Remarks/Arguments

Claims 1 – 16 are pending. Claims 1 – 16 stand rejected. The drawings stand objected to. The abstract of the disclosure stands objected to. The disclosure stands objected to.

FIG. 4

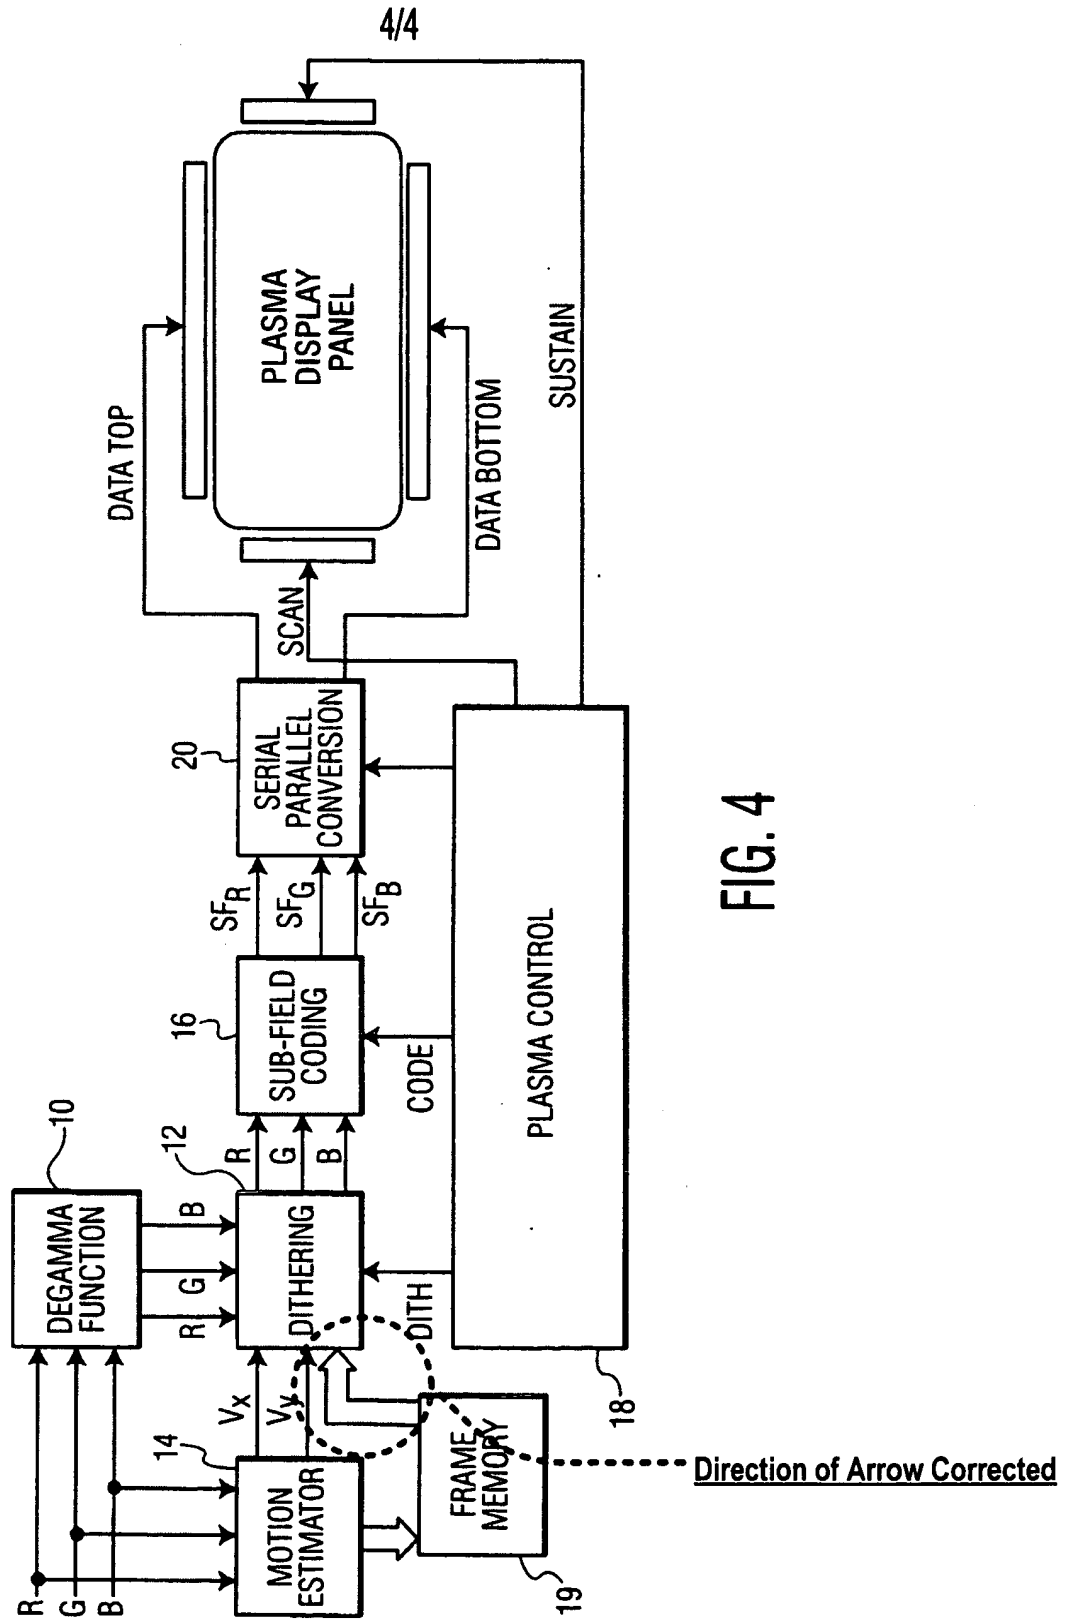
The drawings stand objected to. More particularly, Fig. 4 stands objected to because the specification fails to disclose the item number of the frame memory. Applicant has amended the paragraph beginning on line 8 of page 12, and ending on line 16 of page 12, to refer to frame memory 19. Accordingly, Applicant respectfully requests reconsideration and removal of this objection.

The attached sheet of Drawings includes changes to Figure 4. The attached sheet replaces the original sheet containing Figure 4. The direction of the arrow between frame memory 19 and dithering block 12 has been corrected to point towards dithering block 12.

Figure 4 has been amended herein to show frame memory 19 may be used at the dithering block 19 level, as is explicitly stated on page 12 of the specification, in the paragraph beginning in line 8 and ending in line 16. Accordingly, Applicant submits no new matter has been added.
